## RTB Correction

Model: AD1(LCT Option)		Date: 31-Jan-98	No: 48A
Subject: Paper jam and Noise		Prepared by: K.Ugaeri	
From: QAC Field Information Dept.			
Classification:	<input checked="" type="checkbox"/> Troubleshooting	<input checked="" type="checkbox"/> Part information	<input type="checkbox"/> Action required
	<input type="checkbox"/> Mechanical	<input type="checkbox"/> Electrical	<input type="checkbox"/> Service manual revision
	<input type="checkbox"/> Paper path	<input type="checkbox"/> Transmit/receive	<input type="checkbox"/> Retrofit information
	<input type="checkbox"/> Other (      )

During an internal test, the following problems were found and some parts have been improved from December production '97.

1.LCT UNIT 1(A667)

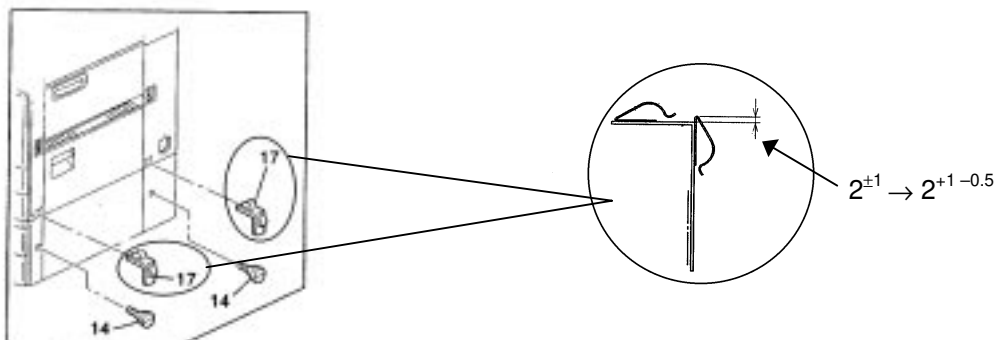
1. When the LCT is installed on the main frame, the spring plate might be cracked.
2. When the dust rubbed off the timing belt gets between the timing pulley and the drive shaft, the rotation of the pulley is affected and paper jams might occur.
3. Rotation noise from the relay roller (but the noise level is still within specification)

1. When installing the LCT, take care not to press the grounding plate too hard.

The shape of the grounding plate has been modified (A6676151->A6676151A) and RCL will supply the countermeasure parts to each subsidiary.

2. Clean the drive shaft of the timing pulleys (P7 – Index 24,**25,27**).

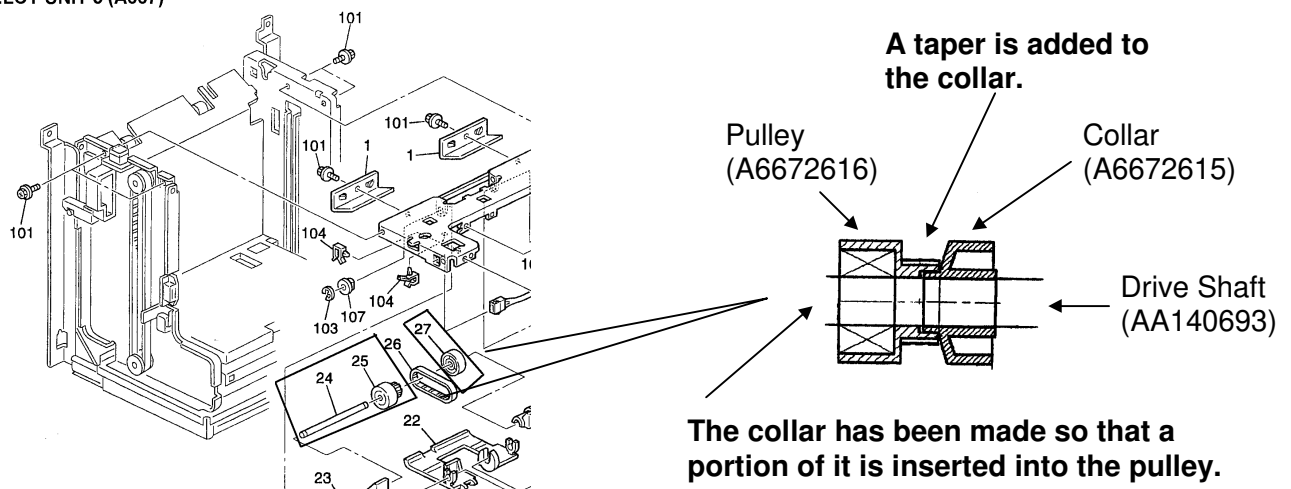
To prevent this problem in the LCT, the material of the shaft and the shape of the pulley and collar have been modified to reduce the dust from the timing belt and to prevent the dust from getting into the pulley. RCL will supply the countermeasure parts to each subsidiary.

1. AA140627 → AA140693 **Drive Shaft – Feed Roller**
  2. H5154713 → A6672615 **Timing Pulley Collar – 6x8**
  3. H5154714 → A6672616 **Timing Pulley – 22Z**
- } X/O as a combination

The interchangeability for these parts is available as a combination.
